## **Some Concerns**

Ernie Nathaniel, March 24, 2020

The proponent, Sio Silica, has come to the province and said it wants to suck up sand from the sandstone aquifer. It's sort of like saying, **"We'd like to extract this high quality sand, but we're going to have to nuke the shale aquitard that separates the two main aquifers (Carbonate and Sandstone) for an area that's about 60% of the size of Winnipeg. Are you o.k. with that?"**

Figure 11: 3D Scan of Cavity (BRU 92-2) – View from East

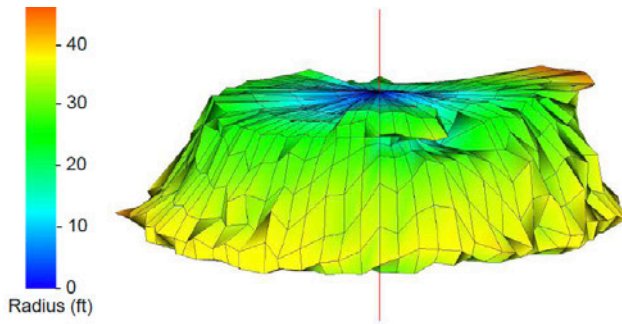
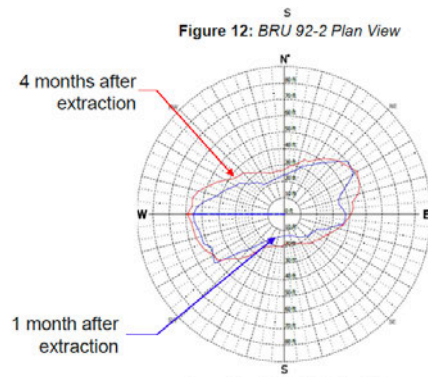
From the recent side scan sonar of the test well BRU-92-8, it looks like a wide cavern is formed, originating in the sandstone aquifer, then the shale aquitard that serves as a barrier to the upper carbonate aquifer collapses. This cavity increases in size into the carbonate aquifer. This cavity appears to grow over time, as the 4 month sonar shows, and since no subsequent sonars have been done to see how far into the carbonate aquifer the cavity eventually grows, or if indeed, it ever stops, we don't what will happen over time. (Stantec Geotechnical Assessment document)

Some geological reports say that the glacial till or overburden is a strong enough support and there will be no subsidence on the surface. This of course depends on the final size of the cavity, which we don't know. As well, we have a pretty thorough mixing of the waters of the two aquifers, against Manitoba Groundwater and Well Act regulation.

Table 12: Extraction Disturbance Zone Size Based on Thickness of Competent Limestone

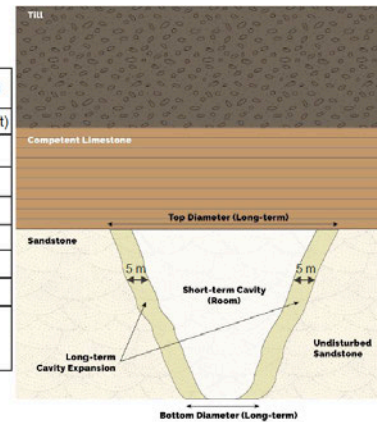
The impact of this aquitard collapse was not fully realized, for me at least, until the CEC Hearings, although the data was previously submitted. The Stantec chart shows the maximum Disturbance Zone Size. But it is interesting to note that the chart only goes to a maximum of 40m diameter top of the extraction disturbance zone (the hole left after the sand is sucked up).

The problem is that in CECIR-009 “extraction of silica sand will create localized voids with a lateral diameter of up to **60 meters** within the Winnipeg Sandstone aquifer. The Geotechnical Analysis of the Project (Stantec, 2022) indicates that in some instances, portions of the overlying Red River Carbonate “cap rock” may collapse into the void. Although not stated explicitly, it is also inferred that the Winnipeg Shale aquitard could collapse into the void.” 60m is 20m greater than the largest allowable dimensions in the above chart, so I found this comment interesting.

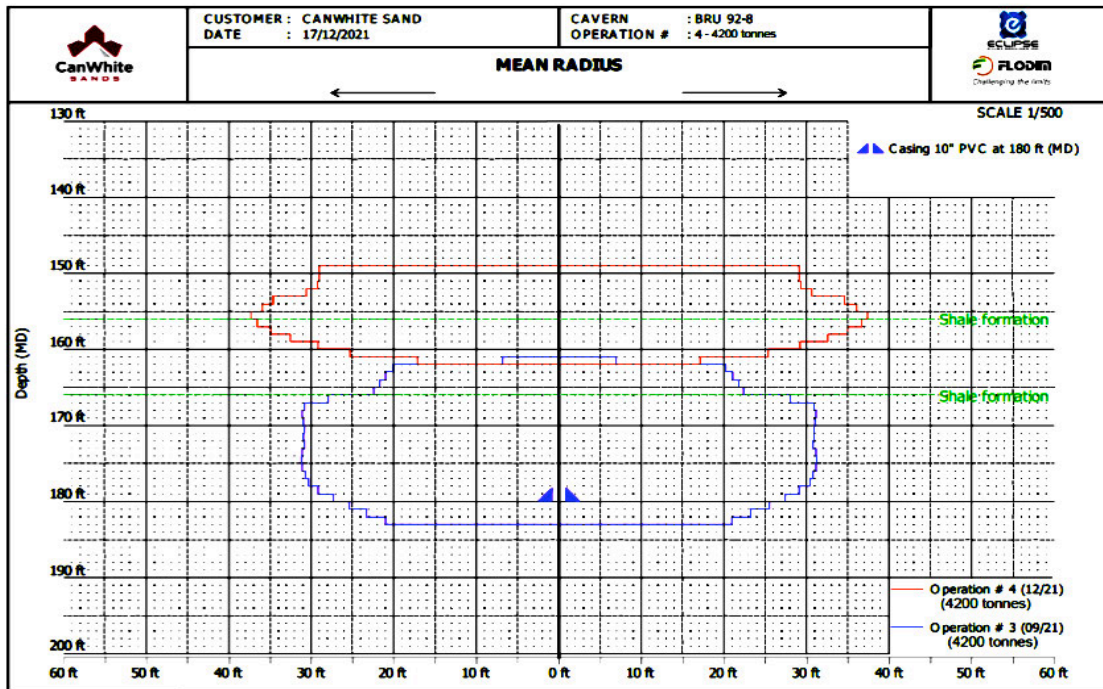
Since only 2 wells were Side Scan Sonar'd, and the shale aquitard of one collapsed, that gives you a 50/50 chance of collapse. No point in worrying too much about cementing around the well at the shale area to avoid connecting the two aquifers, it's open.

The lower blue is the cavity in the Sandstone Aquifer. It has a straight across “shelf” at the bottom because the sonar could not penetrate the cloudy mixture at that point (too much reflection). The upper red diagram shows the cavity extending into the carbonate aquifer (called Limestone aquifer) at 4 months after extraction.

How much higher towards the glacial till (overburden) this grows, we don't know. So, when it says “Intact Limestone remains”, we're not really sure. So we really can't be sure of the level of probability of subsidence / sink holes at the surface.

Figure 2-3: Conceptual Extraction Well and Well Cluster Layout

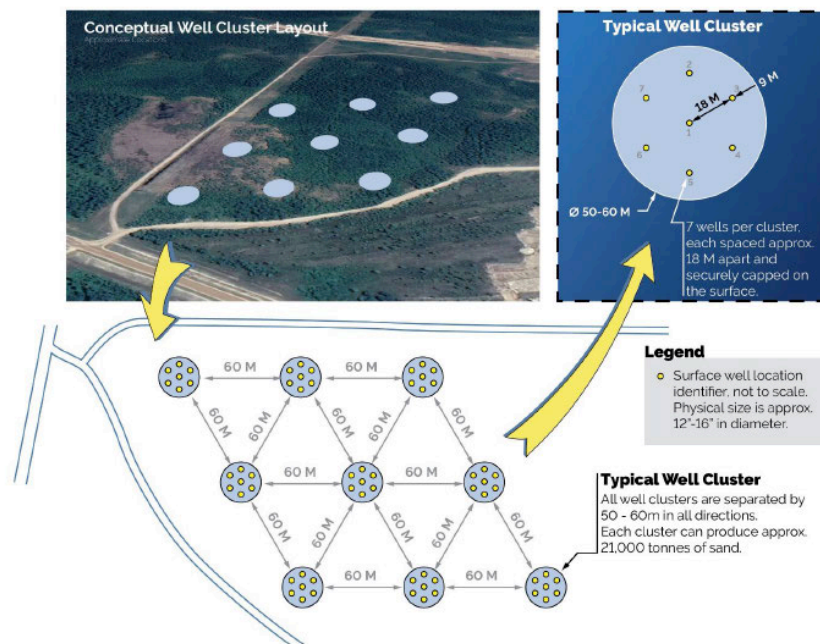
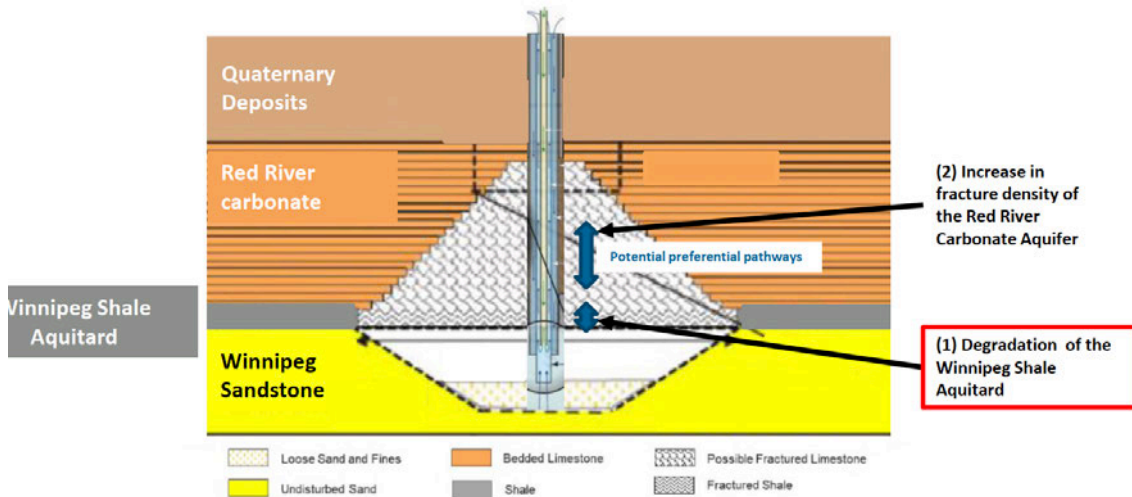
Perhaps this is why what was originally planned as 7 wells per cluster, may be down to 1- 5 wells currently, with a minimum 60m spacing from each. But if each well has a maximum 60m cavity, and they're 60m apart, well it looks like we'll have some pretty large voids. Below: p21, Matrix Solutions presentation at the CEC Hearings

**Bru 92-8 Injection well at SW29-10-8E completed Aug 13 2021  
Permit IW-2021.01-1 issued Aug 11 2021 Quarry SW of Vivian**

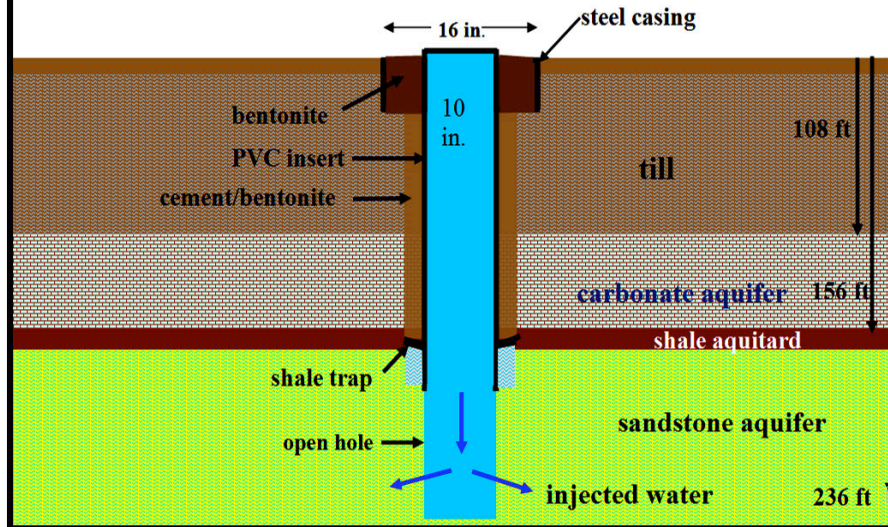
Dennis Leneveu had much concern was dwelt upon well construction, showing the shale trap in Bru 92-8, to prevent the mixing of the two aquifers. However, this is a moot point if there's no shale aquitard. ( diagram from DLN Presentation CEC Vivian Sands Extraction.ppt) Also, the room and pillar method of mining does not apply to sand mining because the sand slopes down, and doesn't maintain the "pillar", therefore the danger of subsidence, as mentioned by MLA Dr. Jon Gerrard.

**Figure 58.** Collapse of limestone in the Sio Silica extraction cavities.  
*Illustration was produced by D.M. LeNeveu including figures reproduced from Sio Silica Hydrogeological Report*

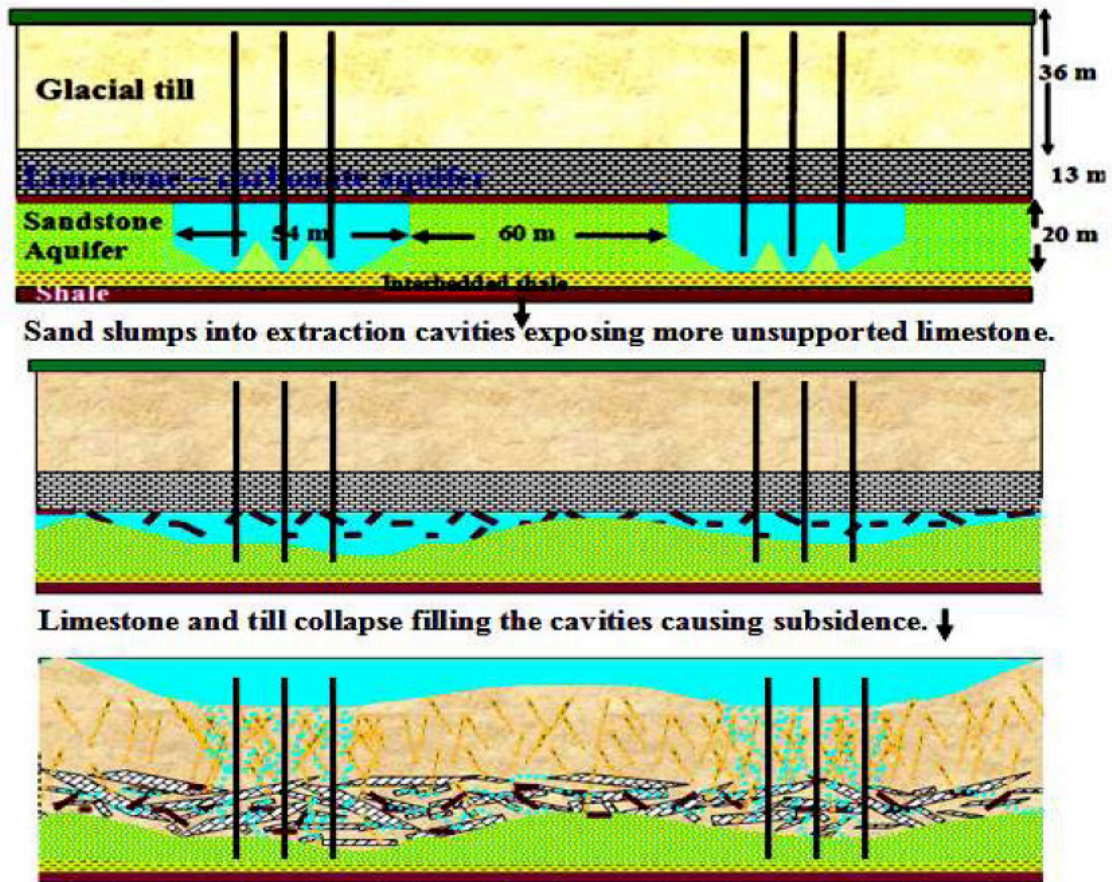
This collapse of the shale aquitard is permanent. **It won't grow back.**

Figure 4-6: Water Treatment Process Flow Diagram for the Proposed CESF System

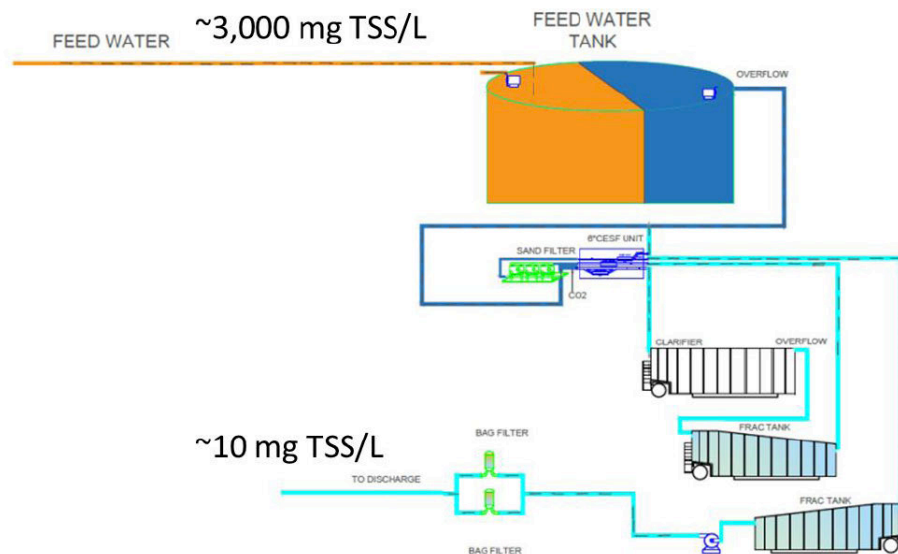
This system as a whole has never been done before and that's why we have these conceptual drawings. And an important caveat on p.16 of the AECOM Supplemental Information 4

*"It is important to note that this equipment is not available for purchase. Renting the equipment is currently the only option."* Of course this greatly reduces the capital cost of the operation.
